Sent: 5/03/2021 2:11:49 PM
Subject: DA2020/1247 CNR-13920 - AMENDED PLANS FOR UNDERGROUND TANK REPLACEMENT WORKS FOR EXISTING 7-ELEVAN – 940 PITTWATER ROAD, DEE WHY
Attachments: 20210212 - Response to TfNSW - Dee Why Petrol.pdf; swepts 210303.pdf; 20210305 - TfNSW Response SYD20_01230_02.pdf;

RE: DEE WHY 7-ELEVEN PETROL STATION
RESPONSE TO MATTERS RAISED BY TfNSW

**AMENDED PLANS FOR UNDERGROUND TANK REPLACEMENT WORKS FOR
EXISTING 7-ELEVEN – 940 PITTWATER ROAD, DEE WHY**

AMENDED SITE PLAN

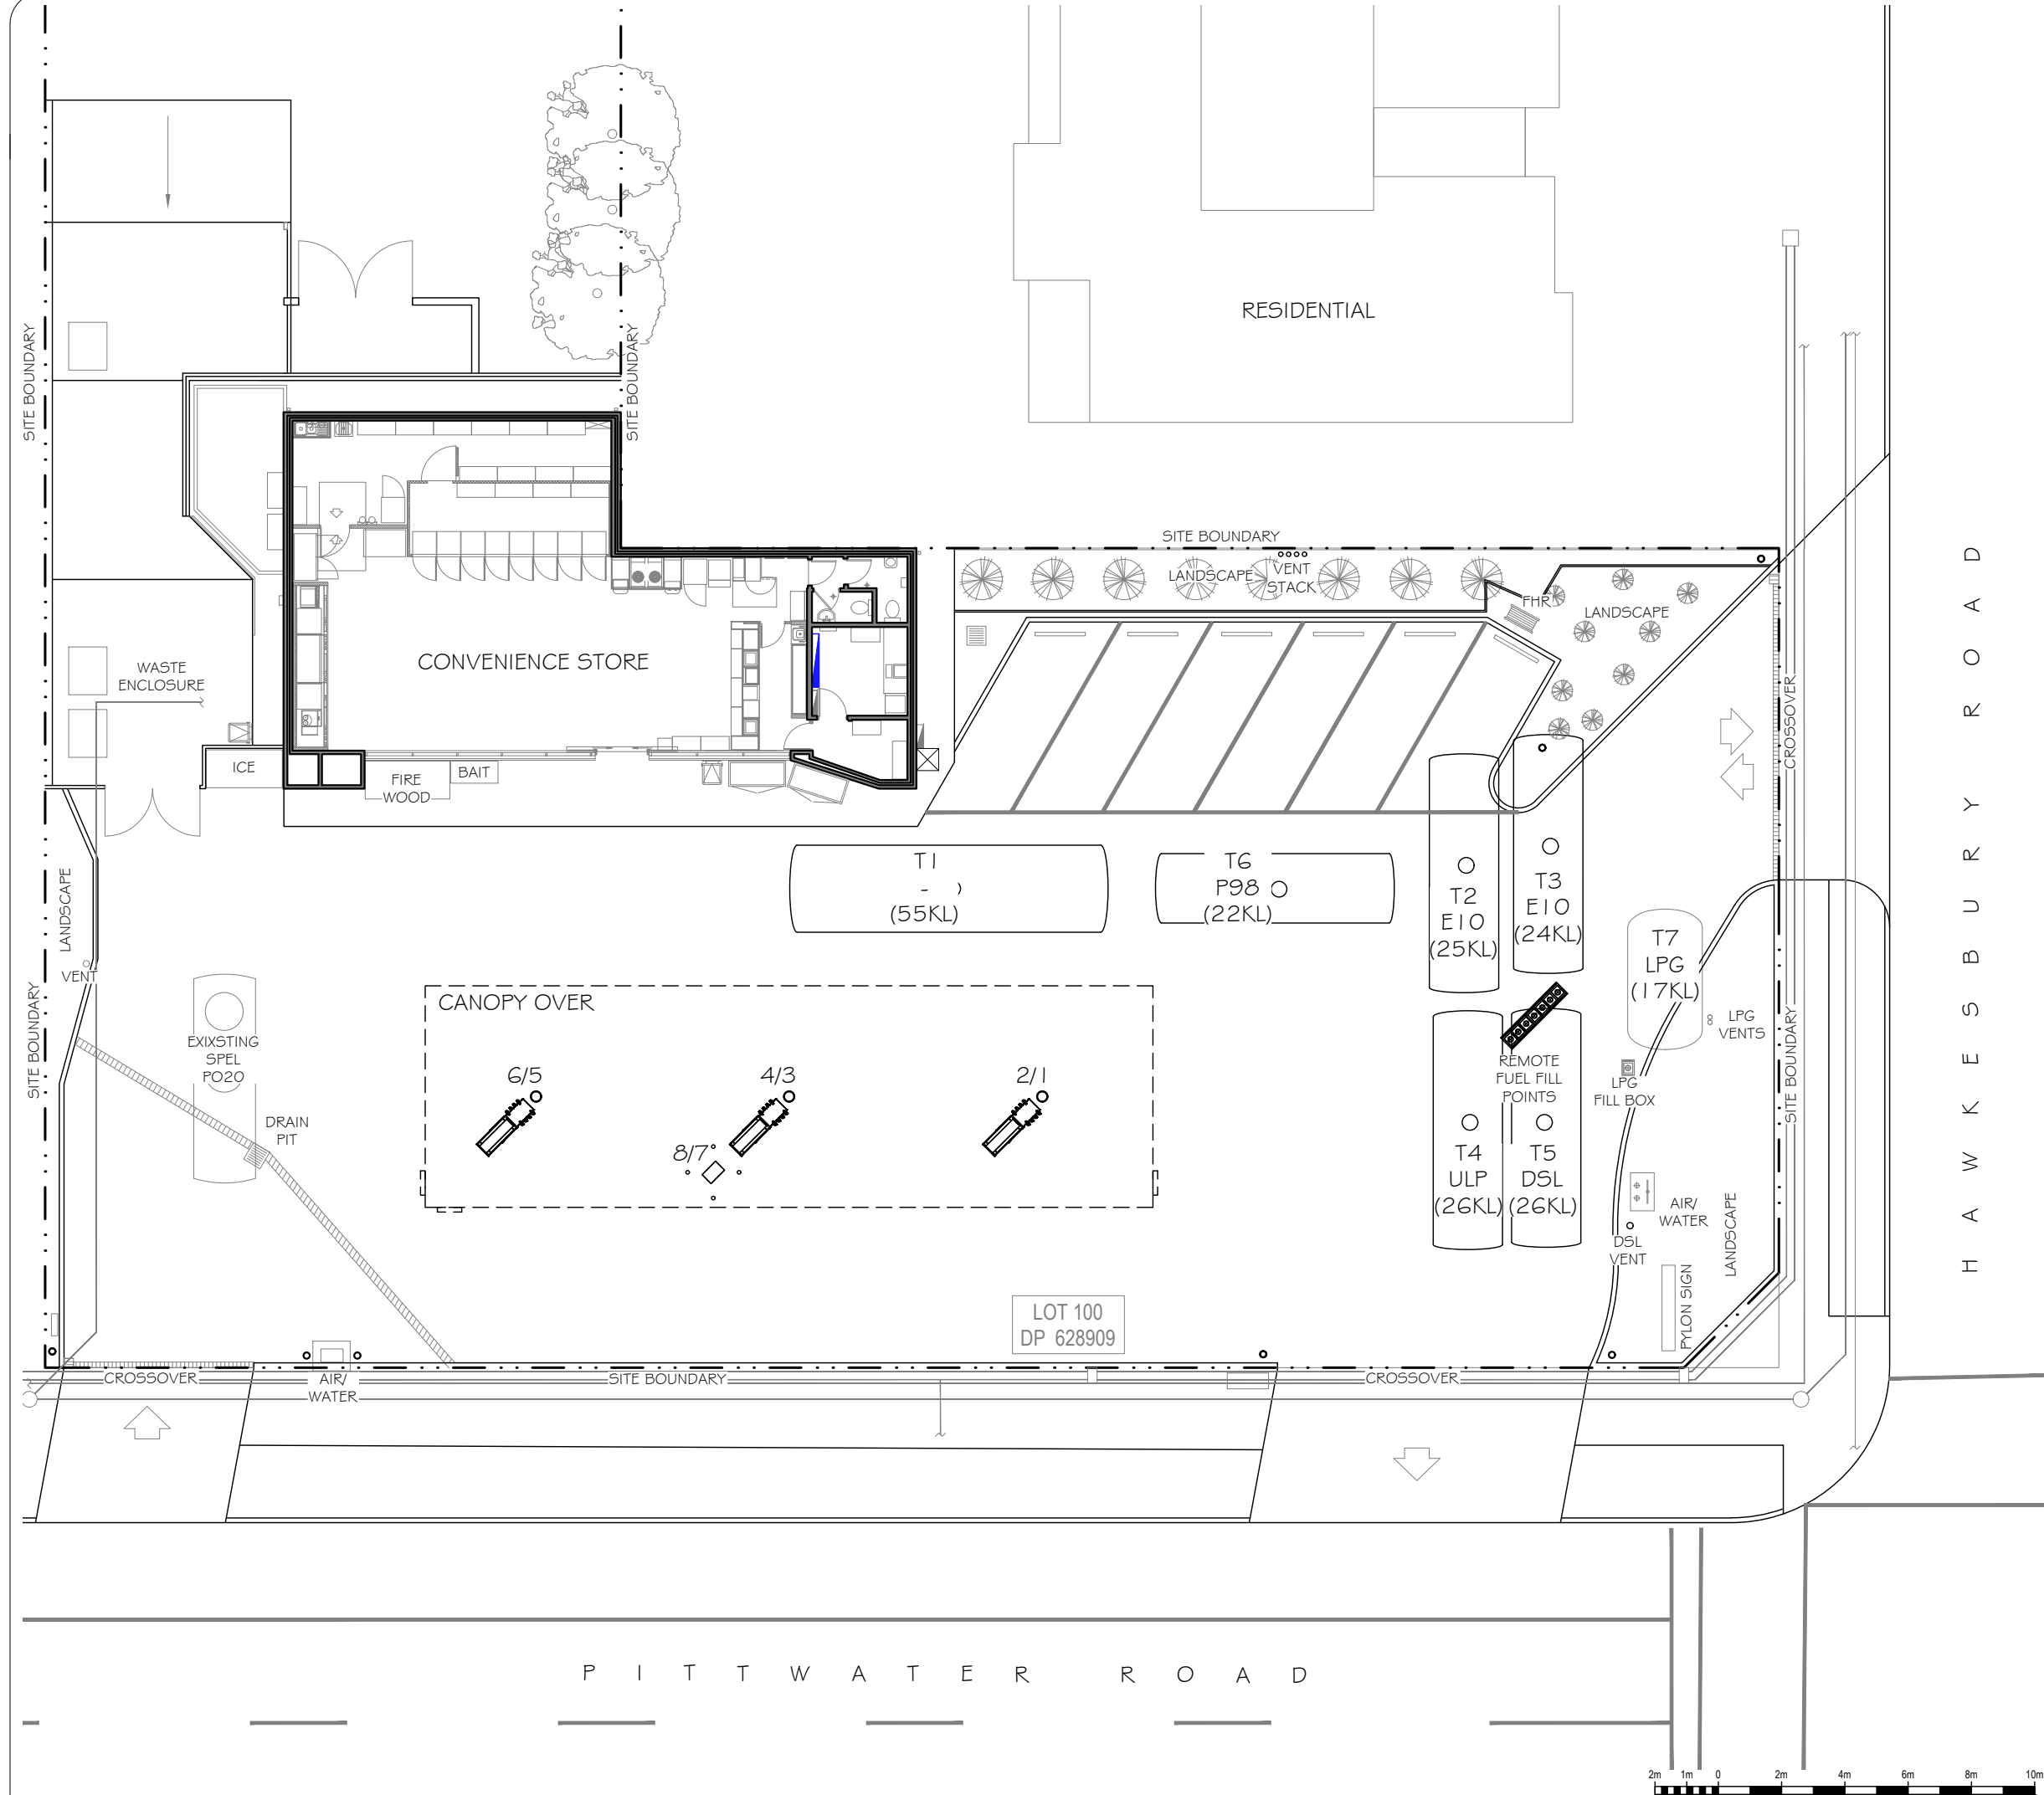
- i. *The submitted plans indicate that the tanker will be blocking two traffic lanes on Pittwater Road within close proximity to the signalized intersection, whenever they are required to wait for vehicles to exit at the proposed entry/exit driveway on Pittwater Road. It is requested that this driveway is changed to 'entry only' to address this concern. All vehicles should exit onto Hawkesbury Road*

- ii. *Another option might be for the proponent to consider widening the first entry driveway on Pittwater Road for the tankers. However, this depends on whether the swept path analysis demonstrates that tankers can enter on Pittwater Road and exit on Hawkesbury Road in a forward direction*

TfNSW has reviewed the amended site plan and swept paths and would provide concurrence to the proposed widening of the existing northern vehicular crossing (entry only) on Pittwater Road under Section 138 of the *Roads Act 1993*, subject to Council's approval and the following requirements being included in the development consent:

2. The existing stormwater pit and Bus Zone sign located within close proximity to the proposed driveway widening works are to be retained, unless TfNSW approval is obtained.

- the northern driveway will be widened (as suggested in the second point of the TfNSW letter). The required widening is shown on the plan provided in Attachment A; and
